TECHNICAL INFORMATION

TI2619

HG SielCup

New features for the SielCup

Segmented operator panel

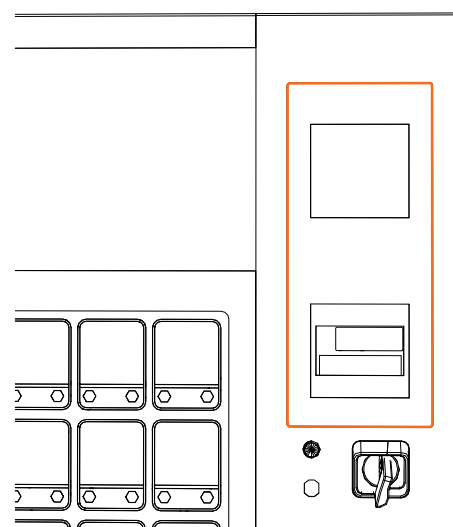
Behind the segmented operator panel a black plastic component has again been fitted in order to keep the gap between the two panels as dark as possible.

New wiring loom for current limiter board

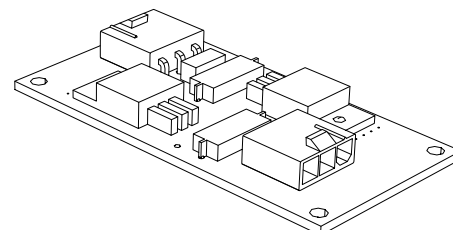
The current limiter board introduced in 2018 minimises the power consumption of the motor responsible for splitting the cups.

This protects the machine against cup stacks which may be stuck together or wedged in. By limiting the power no gears can spring out. If a cup stack is blocked, the operator will know when opening the machine door. For newly-produced machines the wiring loom has been modified.

We have put together a conversion kit for the boards on machines already in the field. Fitting instructions are included in the conversion kit (part no. 413 50 558 00).

Please note that the current software version MSIlv313.pat must be installed on the machine.

New boiler

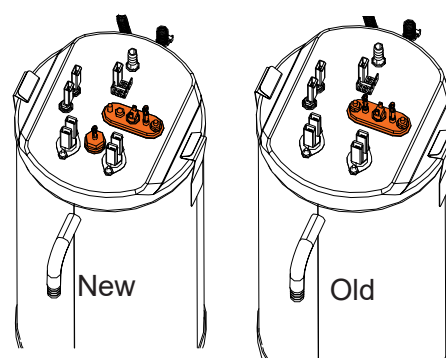
We would also like to advise you that the boiler has been improved. The filling level sensor has been separated from the temperature sensor with effect from serial number 90406914. Should you require spare parts please download the latest version of our spares catalogue from the Download-Center.

Cup guide grip

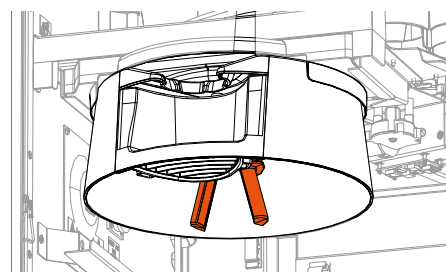
The colour of the cup guide grip (4130007400) has been changed from blue to RAL 2004 (orange). By changing the colour the locking mechanism in the machine is easier to find.
